Product Bulletin

Product Update Notification

Wave 2 of colour change and offer upgrade for TeSys Deca Contactors and TeSys K Contactors

Apr 2022
PB2204.1

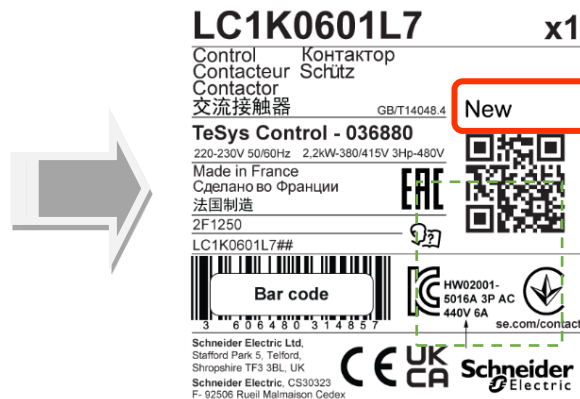
To facilitate an easy identification during this transition period, a word "New" will be added on the package label with old package to identify the items.

Old Label for White Product

Temporary Label* for Dark Grey Product on old package

When the green packaging is ready, we will switch to the new package and remove the word 'New' on package label at same time.
